Product Change Notification

TE Connectivity

Product Change Notification: E-19-003342

T92 Series relay

INK MARKING\_Black cover

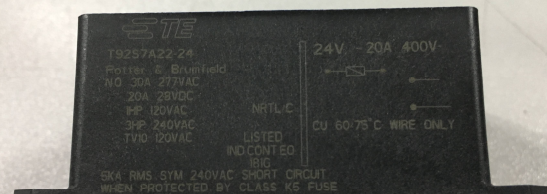
As part of our ongoing efforts to pursuit greener products, TE decided to change T92 relay case marking from ink marking to laser marking. The new laser marking will keep the same marking content completely and no impact on relay function and identification. Please find the attached comparison marking photo.
